February 2017
FL721A-E
NHTSA #16V-656
Transport Canada #16-441
SECOND REVISED NOTICE

Subject: CNG Fuel Tank and CPDM Mounting Location

Models Affected: Specific Freightliner Cascadia vehicles manufactured September 24, 2012, through May 27, 2015, built with CNG fuel tanks

**Fig. 33, Relays and Fuses on the SAM Chassis
(FL721-B installation shown)**

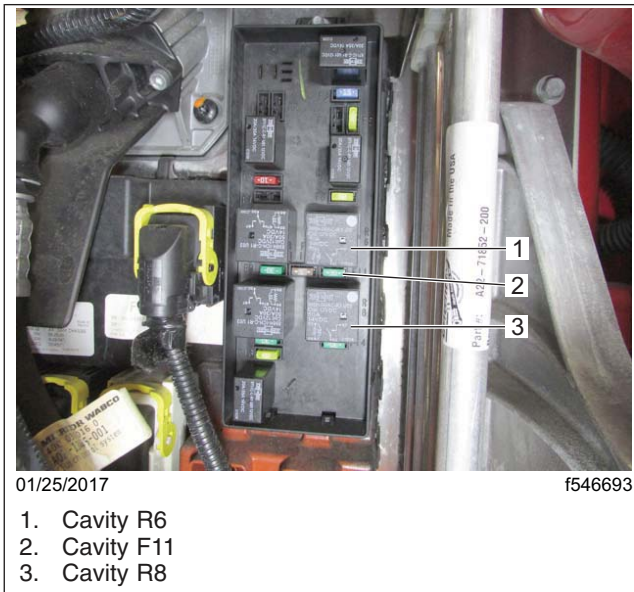
SECOND REVISION: The work instructions for all groups have been revised - FL721-A step 46, FL721-B step 49, FL721-C step 49, FL721-D step 40, and FL721-E step 54.

46. Install relay 23-11276-020 (vendor p/n 896-1AH-C-R1-U03-12VDC) into cavity R8, and verify there is a 30 amp fuse in cavity F14 on the SAM Chassis. See **Fig. 33**

49. Install relay 23-11276-020 (vendor p/n 896-1AH-C-R1-U03-12VDC) into cavity R8, 23-11276-011 (vendor p/n 896-ACH-C-R-U03-12VDC) into cavity R6, a 30-amp fuse into cavity F11, and verify there is a 30-amp fuse in cavity F14 on the SAM Chassis. See [Fig. 33](#)

49. Install relay 23-11276-020 (vendor p/n 896-1AH-C-R1-U03-12VDC) into cavity R8, and verify there is a 30-amp fuse in cavity F14 on the SAM Chassis. See [Fig. 33](#).

40. Install relay 23-11276-020 (vendor p/n 896-1AH-C-R1-U03-12VDC) into cavity R8, and verify there is a 30-amp fuse in cavity F14 on the SAM Chassis. See [Fig. 33](#).

54. Install relay 23-11276-020 (vendor p/n 896-1AH-C-R1-U03-12VDC) into cavity R8, 23-11276-011 (vendor p/n 896-ACH-C-R-U03-12VDC) into cavity R6, a 30-amp fuse into cavity F11, and verify there is a 30-amp fuse in cavity F14 on the SAM Chassis. See [Fig. 33](#).
